Town of Medley

Date:	July 26, 2014
Subject:	RFP for Construction of Interior Alterations to the Medley Municipal Services Facility (MMSF Police Department Expansion)
Solicitation Number:	RFP 2014-03
OCPDS Number:	PS-1301
Opening Date / Time:	July 29, 2014 at 2:00 PM (Changed by this Addendum to Thursday, July 31, 2014 at 2:00 PM)
ADDENDUM Number:	3

Addendum 3 does the following:

SECTION 2
SCALE: 3/8" = 1'-0"

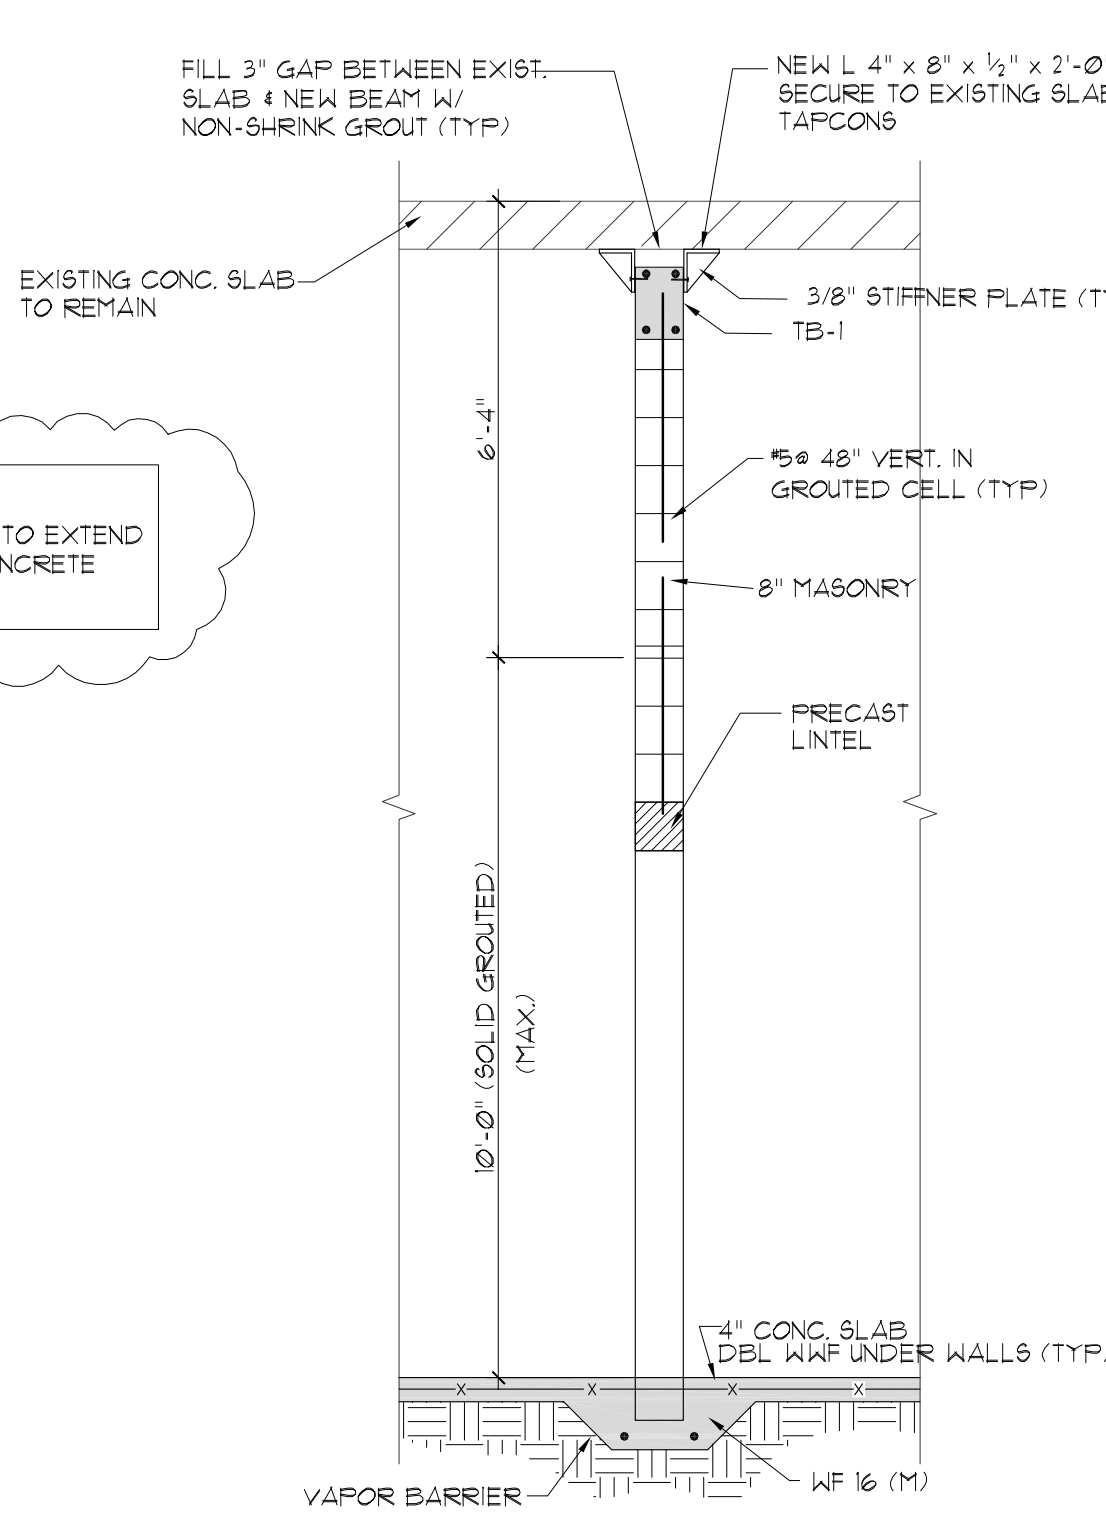
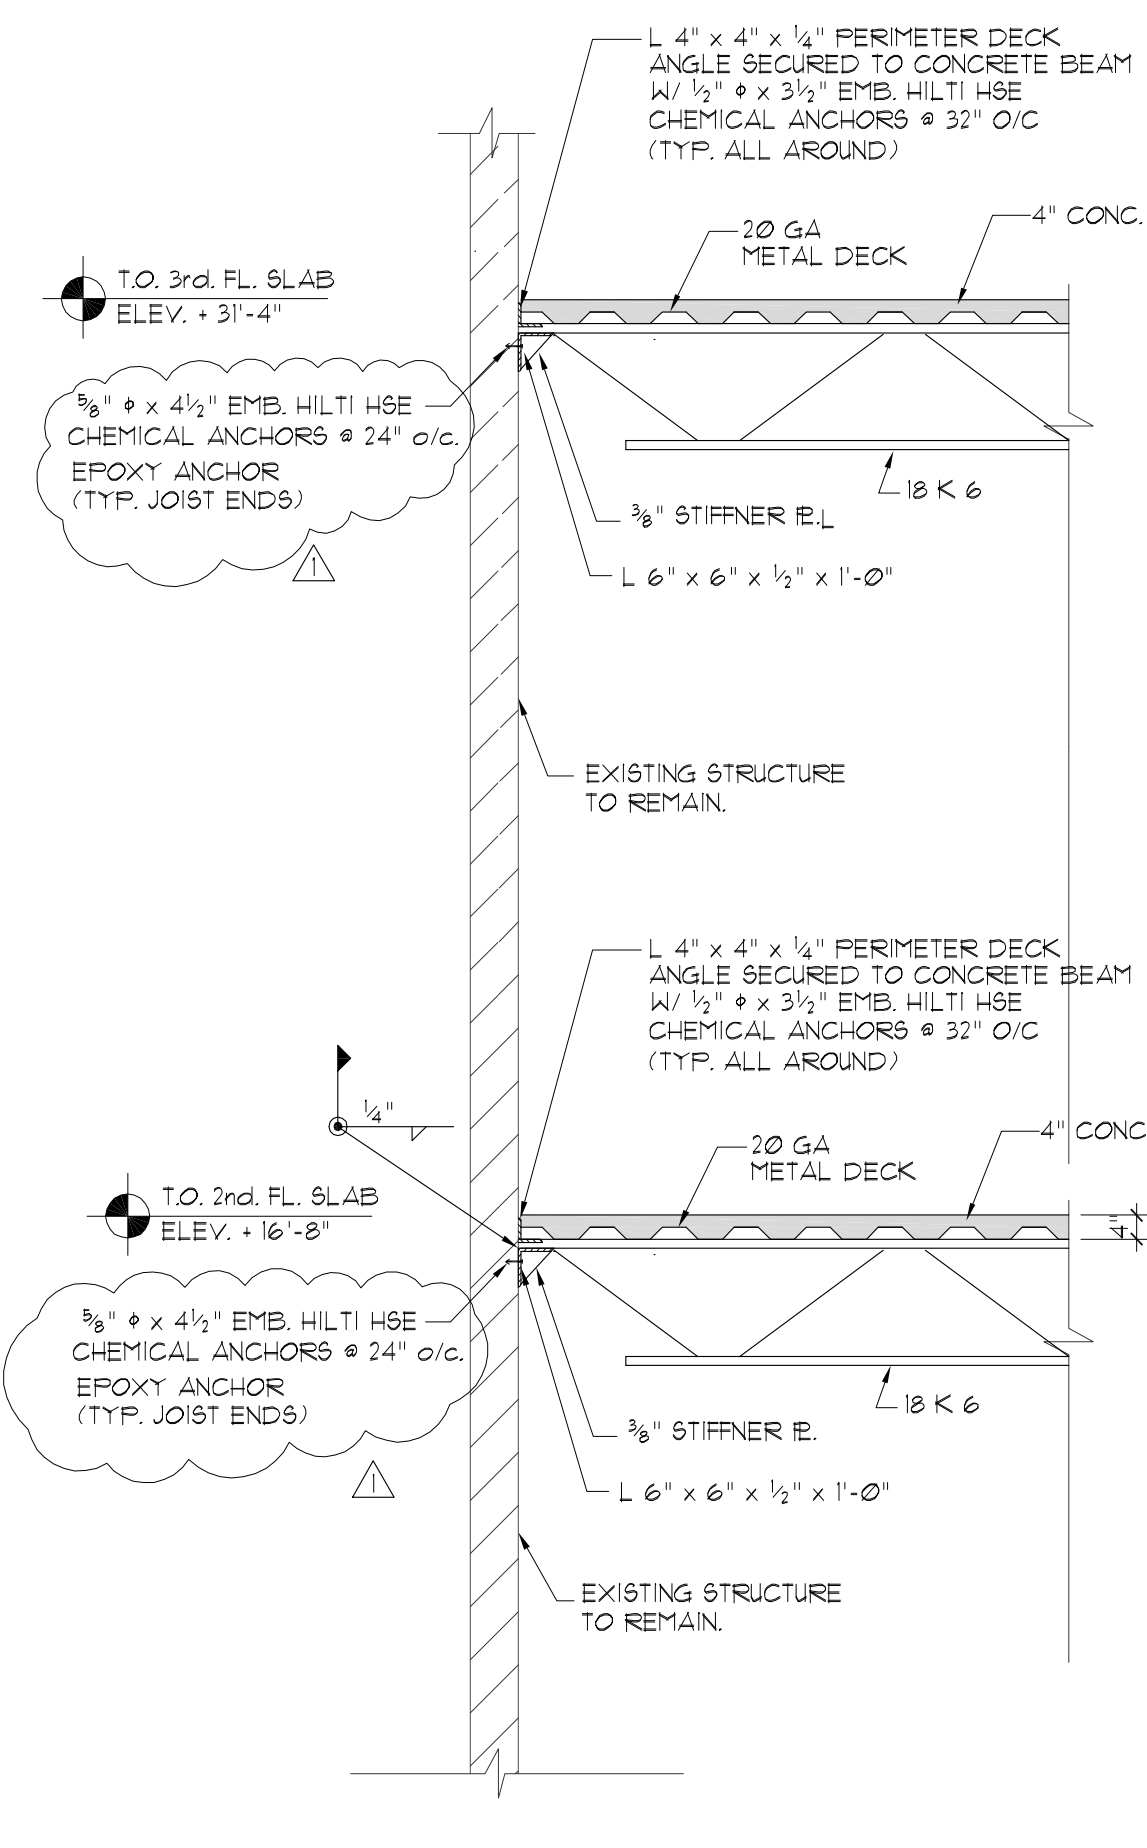
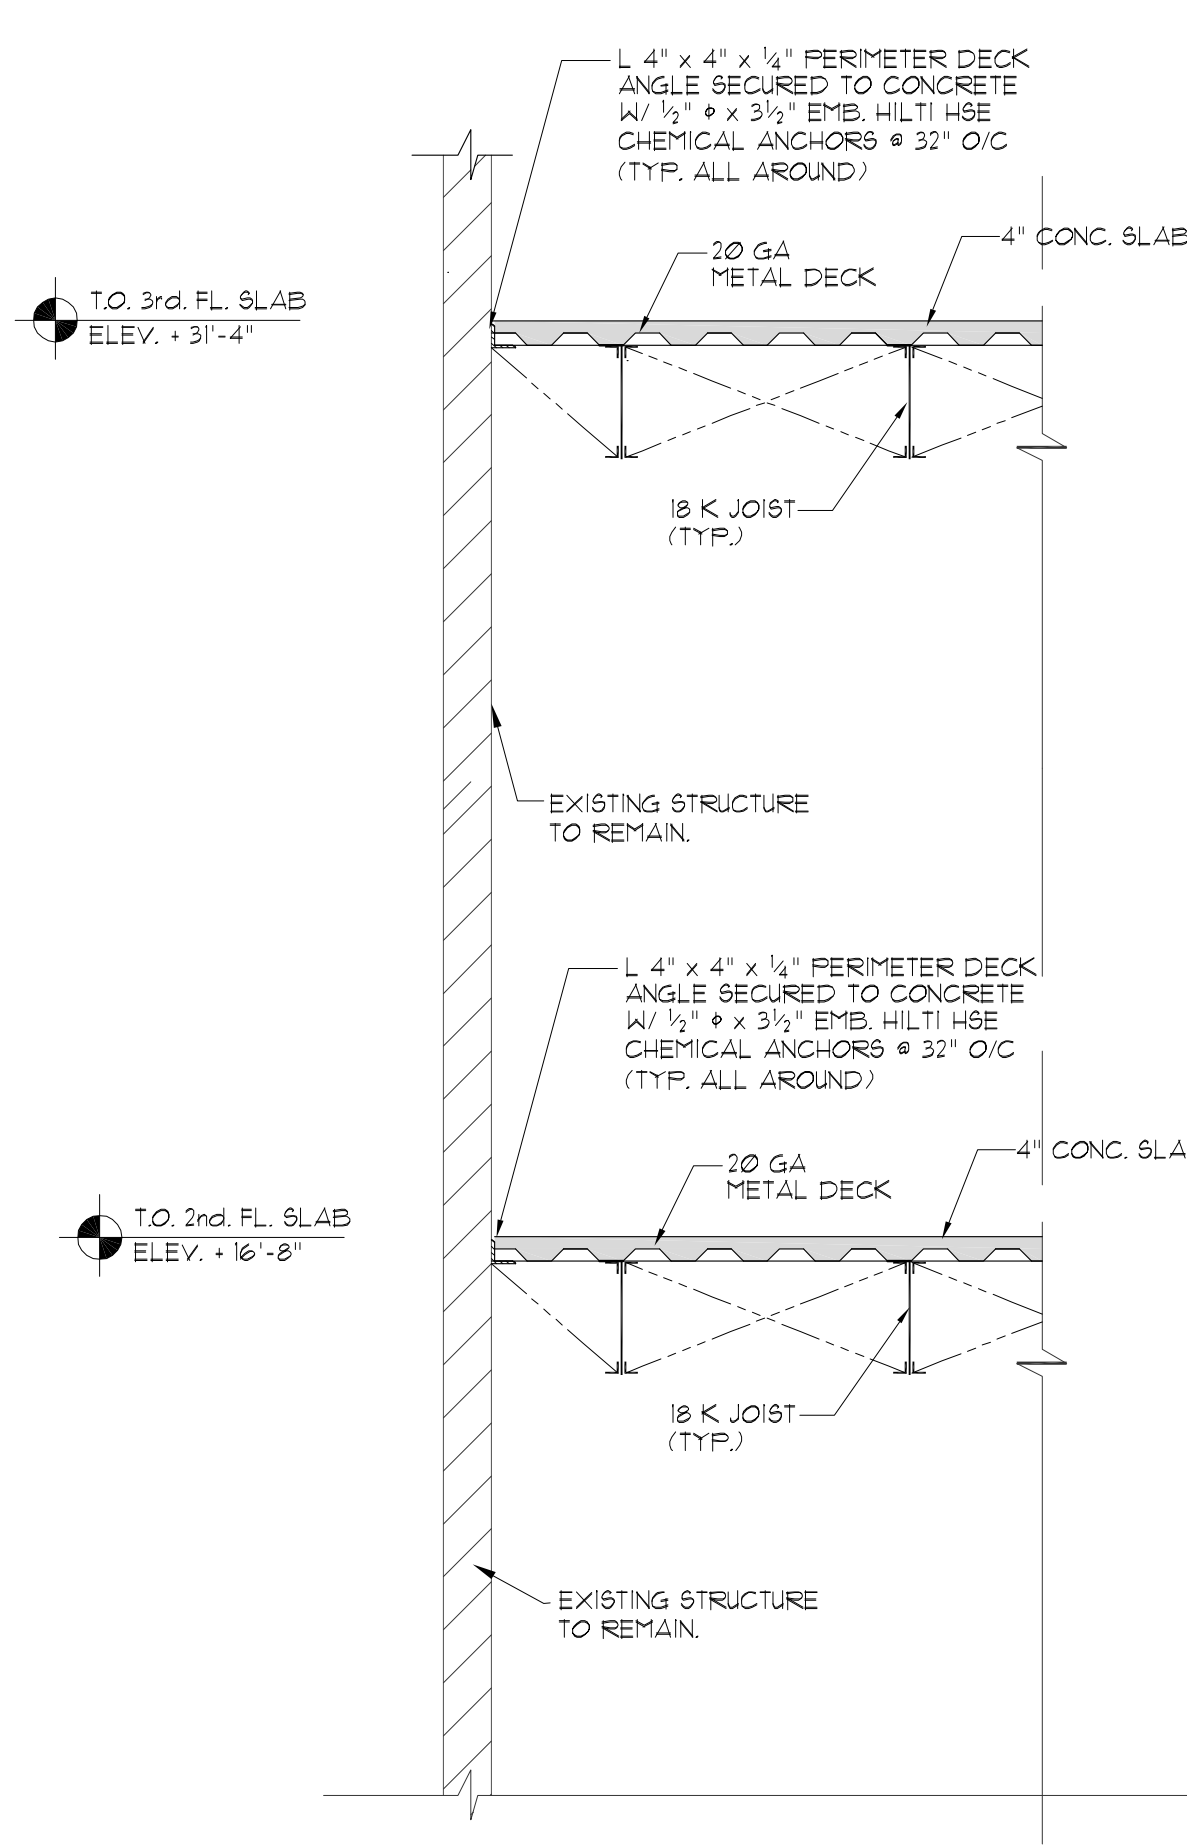
RFI No.	RFI Ref.	Question	Responses
A3-012	E-002	Provide location of security pool	Fire Alarm panel is located behind the elevator core. Access is through parking garage
A3-013	E-003	Lobby 118 calls for (3) fixtures on east part of room. Please clarify if new or existing	Lights are existing to remain
A3-014	E-004	Rooms 116, 117, 118 call for new fixtures tied to EM circuits. Are they night lights? Should they turn on with rest of fixtures? There is no relay shown	They are intended to be night lights
A3-015	B-005	There seem to be discrepancies between the structural and architectural drawings as follows;	Attached is revised Structural sheet S-1 addressing all discrepancies

1. The electric drinking fountain niche seems to be approximately 14" off	
		2. Structural does not shown on the CMU wall continue to form the drinking fountain niche

3. Structural does not indicate 2 beams and CMU walls	
A3-016	B-006	Is there a detailed Finished Hardware Schedule for this project? The hardware schedule found on A-16.1 is not accurate and complete. Hardware set SH02 are for Doors 03, 06. The problem is that door 06 is a pocket door while hardware set SH01CELL are for doors 04, 05 and door 04 is for holdings cell while door 05 is for the Men's Locker. Please advise...	Hardware type SH01 is for doors # 03 & 04, Hardware type SH02 is for doors # 01 & 02, Hardware type SH03 is for doors #1-A (two doors). Hardware type SH04 is for door #1-B. The plans call for the Contractor to match the existing doors and hardware and to submit a complete schedule hardware schedule for the balance of the doors (doors #5 thru #26)
A3-017	E-005	Can you please provide specifications for the Epoxy Flooring and Wall Covering noted on the Finish Schedule? We have similar products but would like to confirm performance specifications meet the designed product	Attached are the specifications for the Armor-Glaze system by Vanberg. The plans call for the Armor-Glaze for the walls and the Armor-Slate for the floor

1. In Section 1 - Notice to Proposers:
 - a. In the first paragraph the submittal date for the proposal has been changed to **July 31, 2014 at 2:00 PM.**
2. Provides responses to additional Request for Information (RFI’s) submitted for the Project and issued to date.
3. Provides revised Structural drawing Sheet S-1 in response to RFI A3-015.
4. Provides technical specifications for the Vanberg Armor-Glaze system in response to RFI A3-017.
